RE: DRAINAGE PLAN FOR AN ADDITION TO WALMART STORE #824
(G-19/D4) ENGINEER'S STAMP DATED MAY 23, 1989

GRADING AND DRAINAGE PLAN
WAL-MART STORE # 824 STOCKROOM ADDITION

LA MIRADA SQUARE AS-BUILT GRADING PLAN

RE: DRAINAGE PLAN FOR IMPROVEMENTS TO LA MIRADA SQUARE
(G-19/D4) ENGINEER'S STAMP DATED MAY 18, 1989

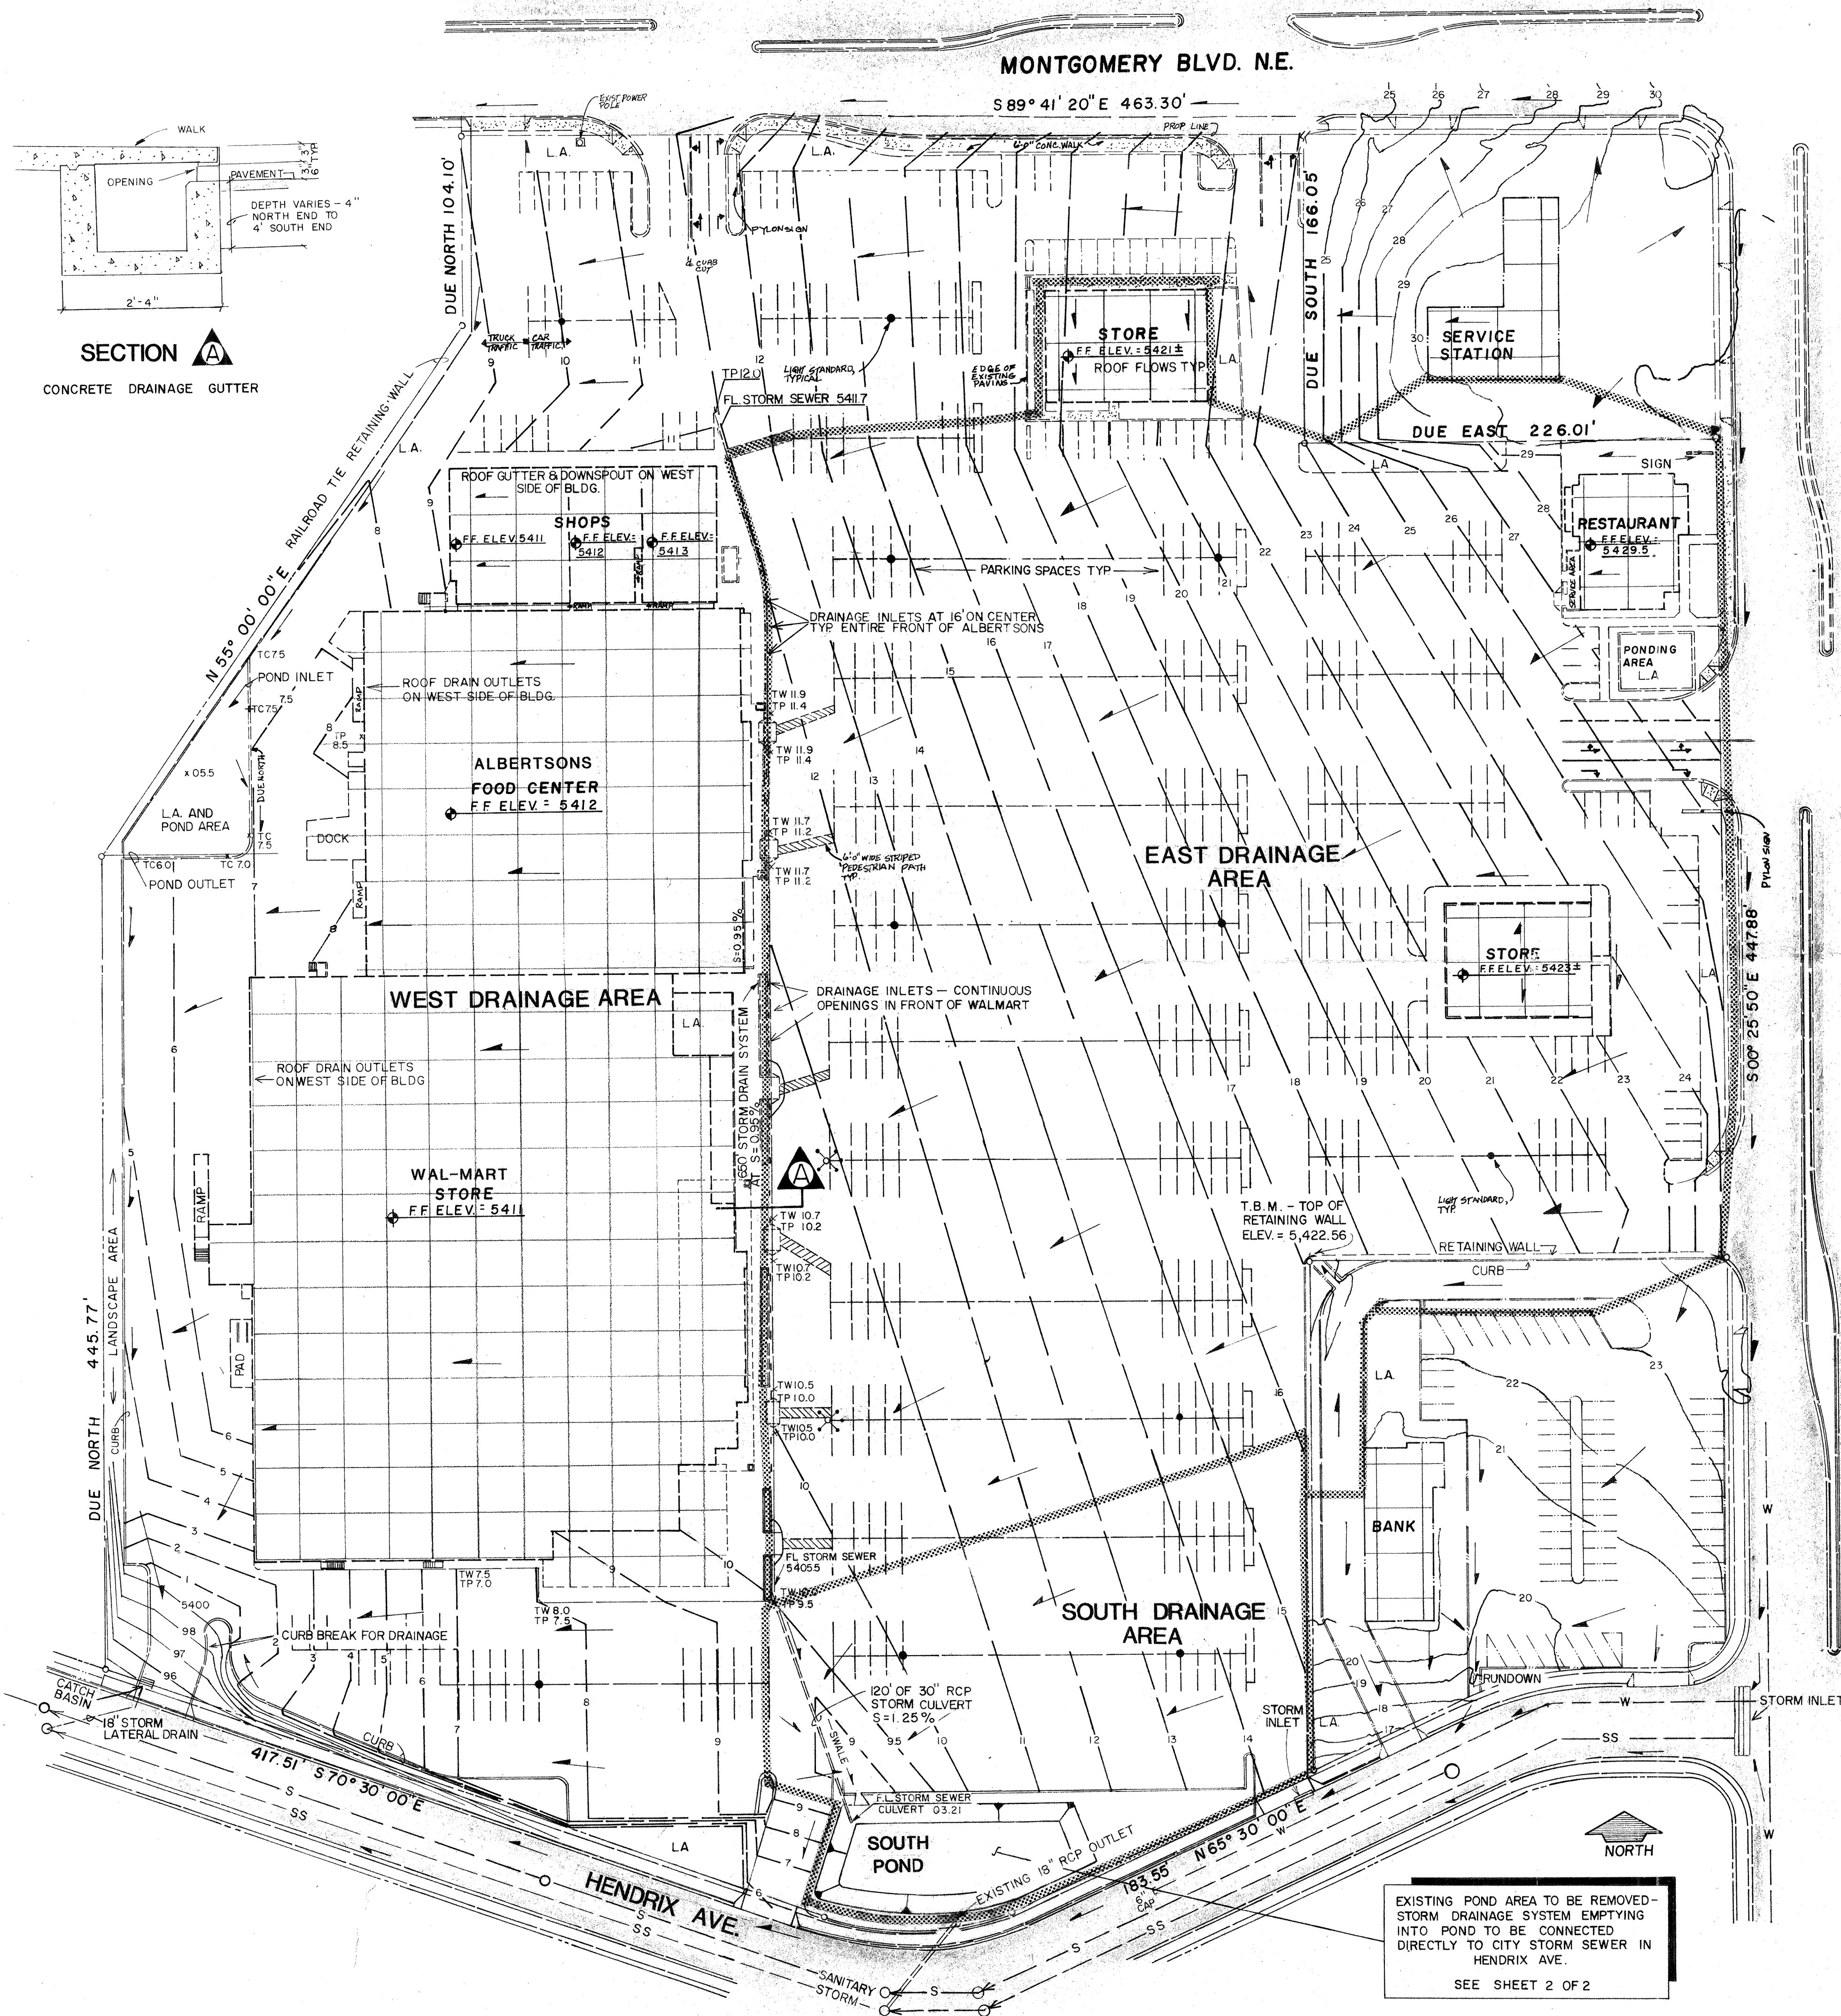
Based on the information provided on your submittal of May 24, 1989, the above referenced plan is approved for Building Permit.

Please attach a copy of this plan to the construction sets prior to sign-off by Hydrology.
